**ADDENDUM #2**  
**August 26, 2024**  
**Fort Chiswell South Sewer Extension Phase I**  
**Wythe County**

WYTHE COUNTY  
FORT CHISWELL SEWER EXTENSION  
ADDENDUM 2  
DRAWING A2-1  
AUGUST 2024

**RESIDENTIAL WATER  
METER CONNECTION**

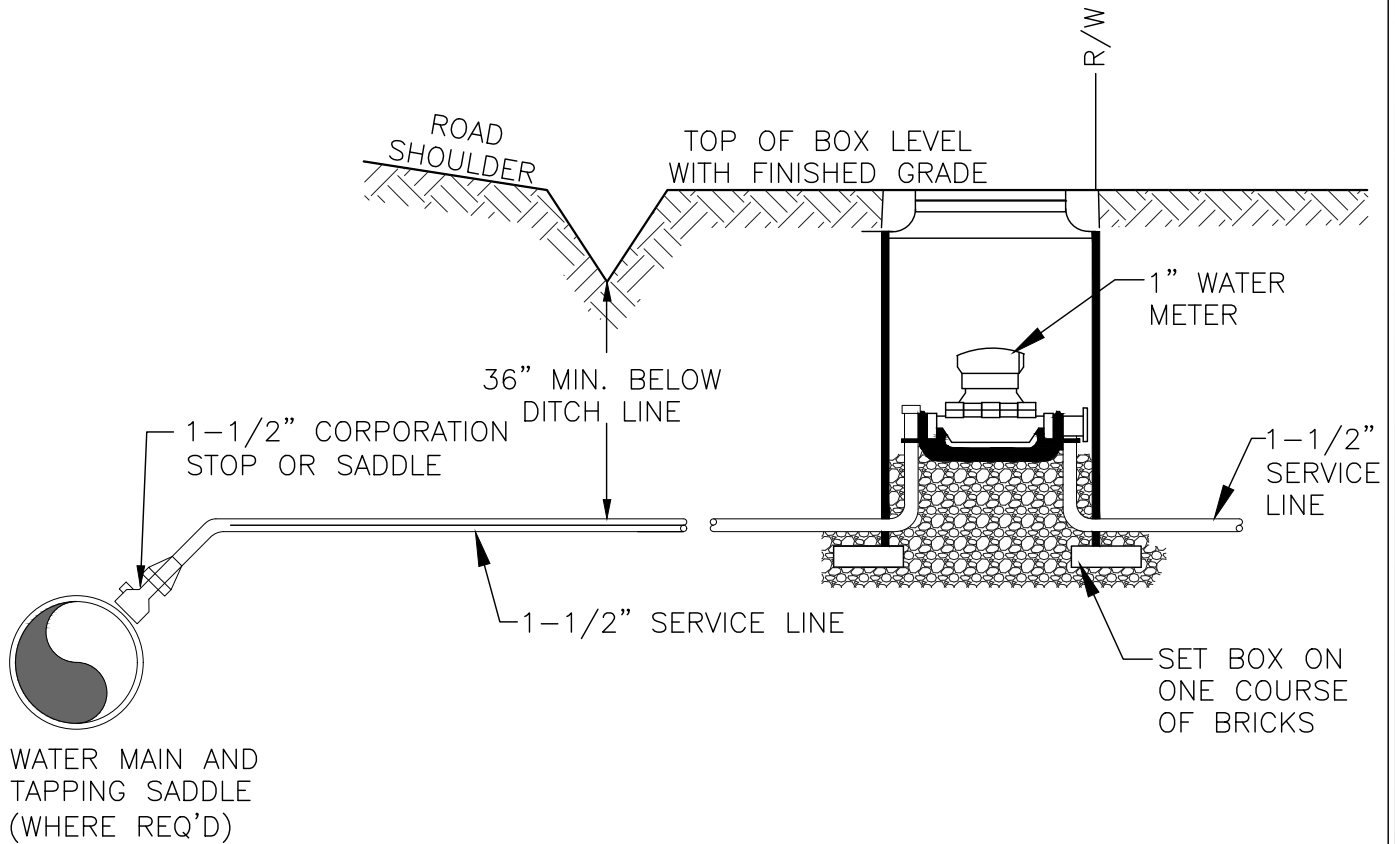
1. Add Note #11 to Drawing C07 stating “Yard hydrant shall be Woodford Model S3 Sanitary Yard Hydrant or approved equal.”
2. Correct the second note #8. to read note #9. under Electrical Notes On Drawing C08 to read:  
**9. UNLESS OTHERWISE NOTED, ALL ~~INTERIOR~~ ELECTRICAL ENCLOSURES SHALL BE MINIMUM NEMA 1 AND ALL EXTERIOR (ADJACENT TO THE WET WELL) ENCLOSURES SHALL BE MINIMUM NEMA 3R.**
3. Add note Electrical Note #10. On Drawing C08 to read:  
10. Generator wiring shall be either delta or 4 wire Y.
4. Add drawing A2-1 to Drawing D03 for the water meter detail
5. Revise Drawing C08 Yard Light Detail to indicate fixtures to be minimum 7,300 lumen LED Floodlights.
6. Revise Drawing C07 to delete snapcap diffusers and ¾” air line.
